KMR.CDD.OIQ.1916.05

ORDERS UNDER SECTION 96 (2) OF ACT, III OF 1910.

PLAN OF PROPOSED HOUSE ON PLOT Nos 115 & 136-B

NOTICE UNDER SECTION 96 OF ACT III OF 1901.

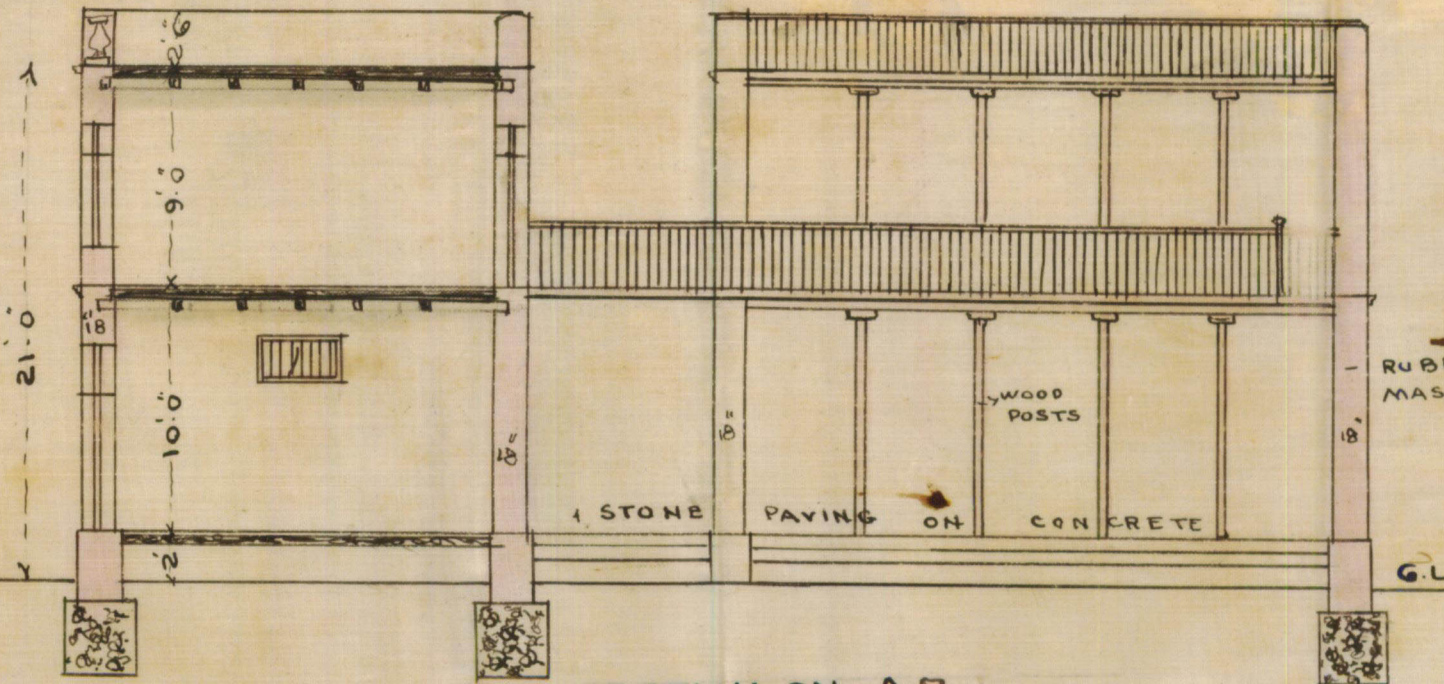
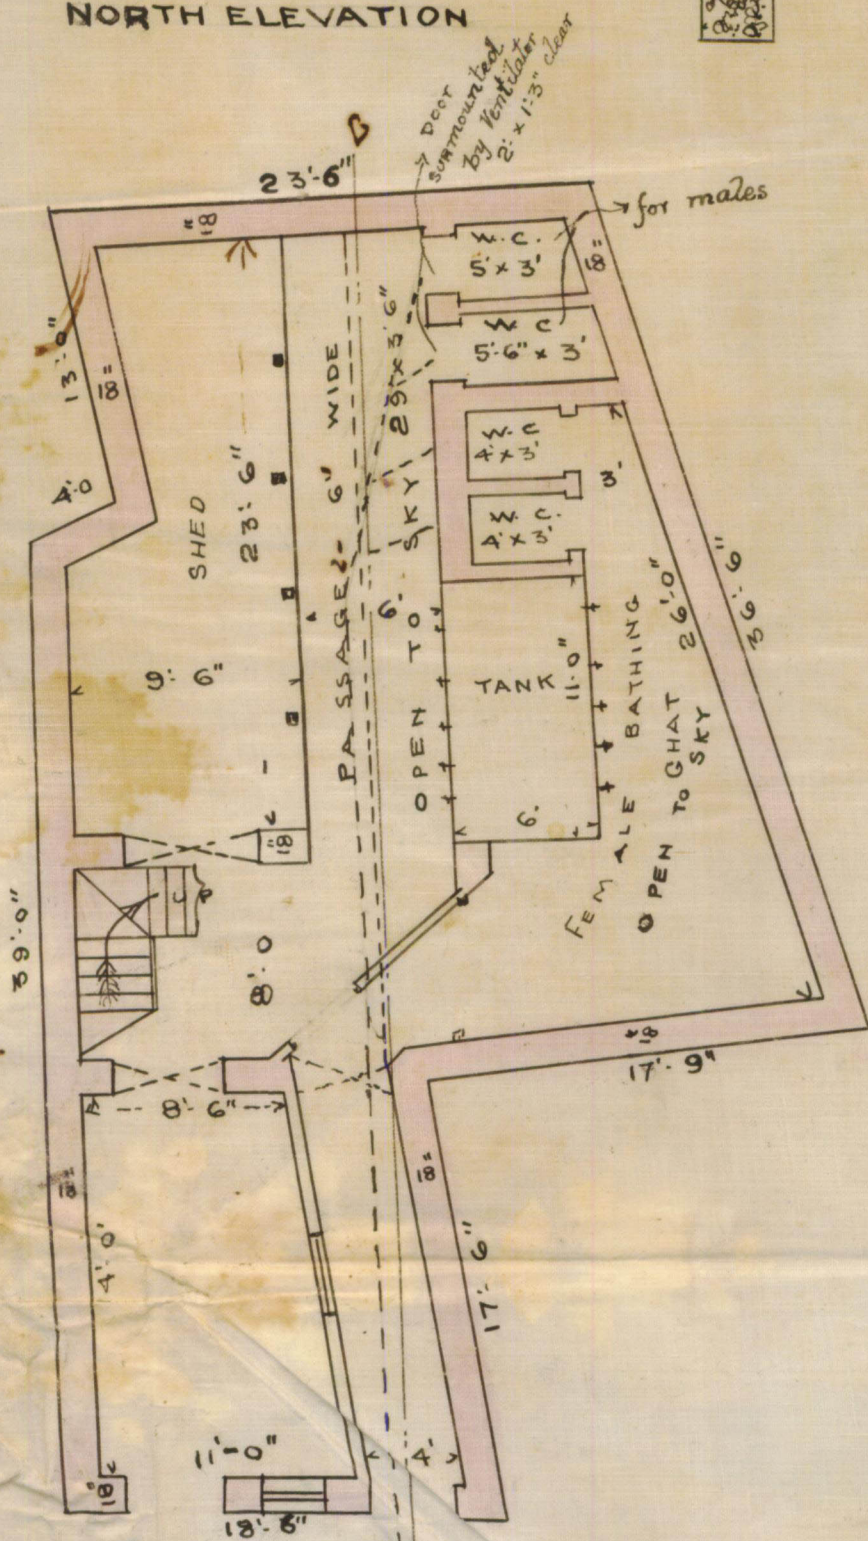
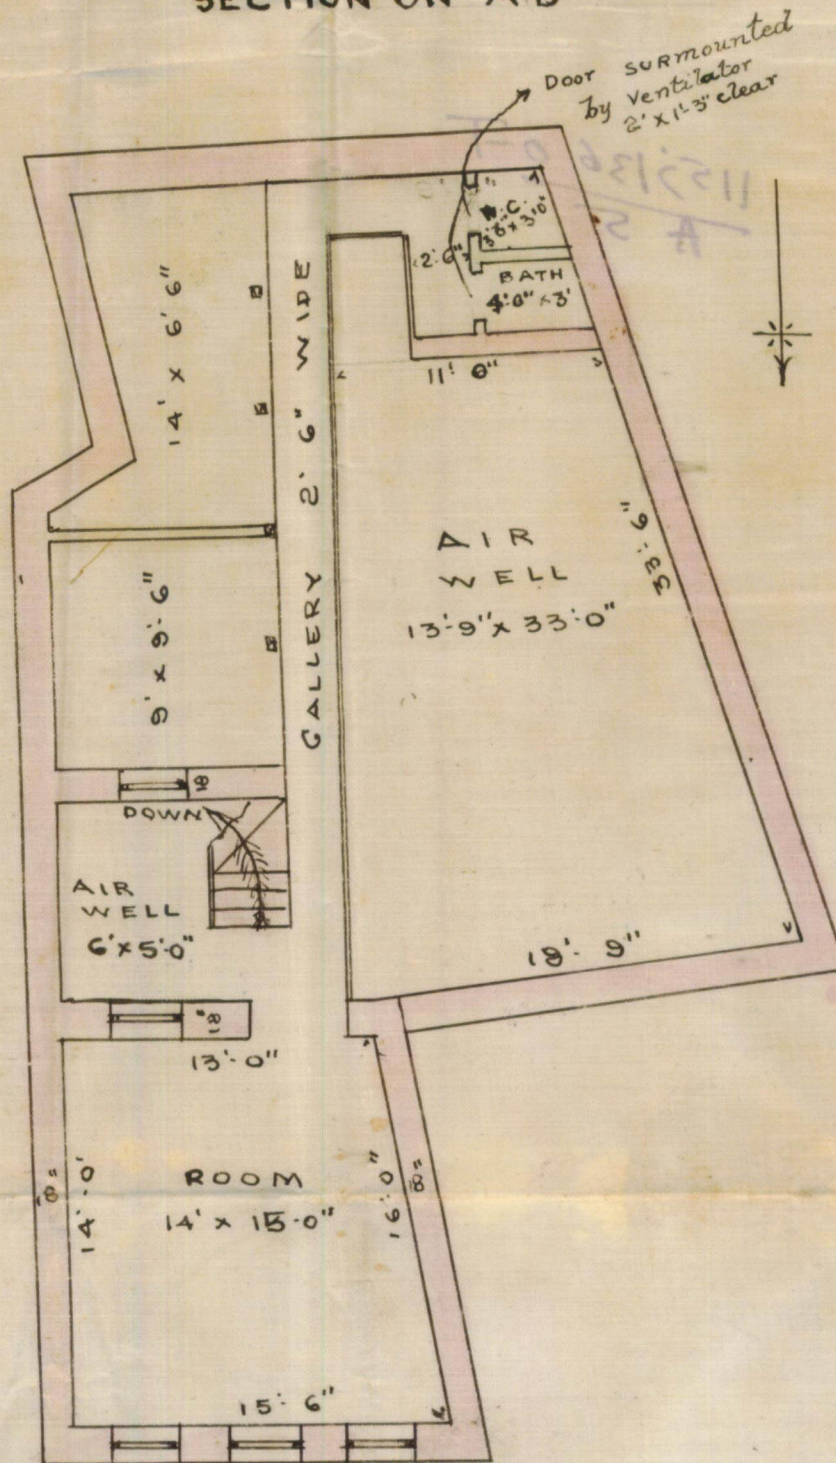
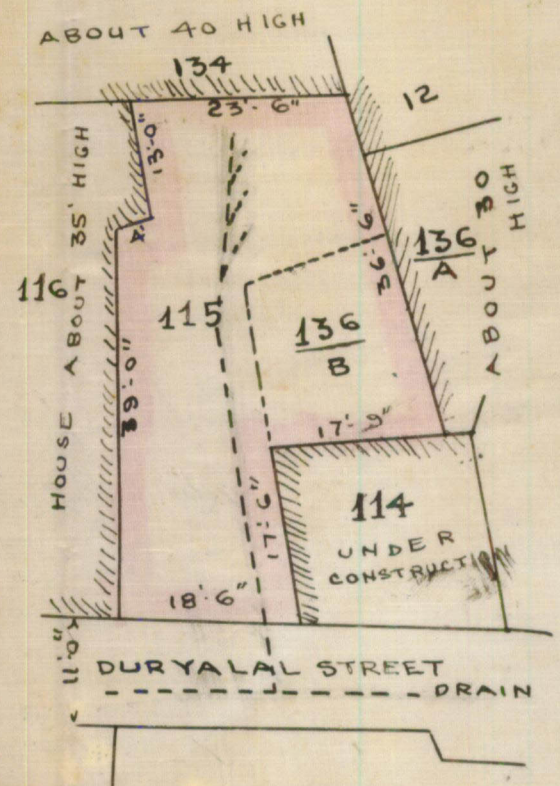
with a request that only a metered water supply should be given to the owner of above building as the same is to be used for the purpose of Bathing Ghaut.

Applicant's name Mahesh Patel MangiWhether he is the owner of the plot on which it is proposed to build HydrabadThe work proposed Build a house with bathing gharEnquiry Officer's report SeeI beg to report that the W.C. on the first floor do not seem to be in accordance with the by-laws. The foundation is not good.Date 26th April 1916.Enquiry Officer.  
BUILDING INSPECTOR.

Does the plot come under Alignment NoArea of plot                     Area under Alignment                     Remarks Sir, With reference to this I beg to this I beg to know whether the bathing ghar can be built in this part of the plot. There is one street of Wawa Community to the same level.Date 27-4 1916.

For permissionE. Y.Capt. I have the information that only a method with a bath should be givenCan be given. a/c
